HP MODEL 5345A ELECTRONIC COUNTER

Serial Prefix 1920A and Below

MECHANICAL INTERCONNECTION WITH PLUG-INS

Proper Cable Routing

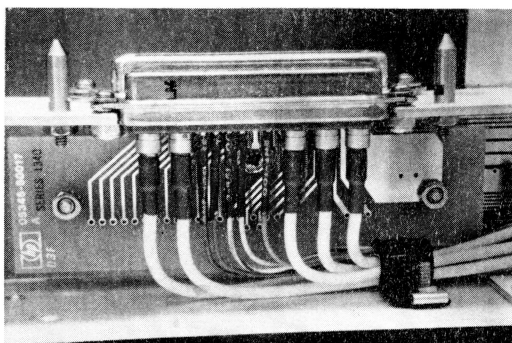
A few 5345A mainframes have exhibited a reluctance to easily accept mechanical interconnection with plug-ins. On inspection of these units, it was determined that the coax cables within W5J1 plug-in connector are tied in such a way as to force the rf connectors off center. This prevents them from properly mating with their plug-in counterparts.

If this condition exists in a field unit, use the following technique to properly align the rf cables: within the 5345A plug-in compartment, remove the four screws holding the connector cover. Remove the cover from the connectors to expose the connector wiring. The wiring from the top connector (W5J1) runs through a clamp which is attached to the rear panel. Loosen this clamp and move the wiring so it is perpendicular to the connector (i.e., so it goes straight back from the connector and is not immediately pulled to one side). Tighten the clamp connection and replace the cover.
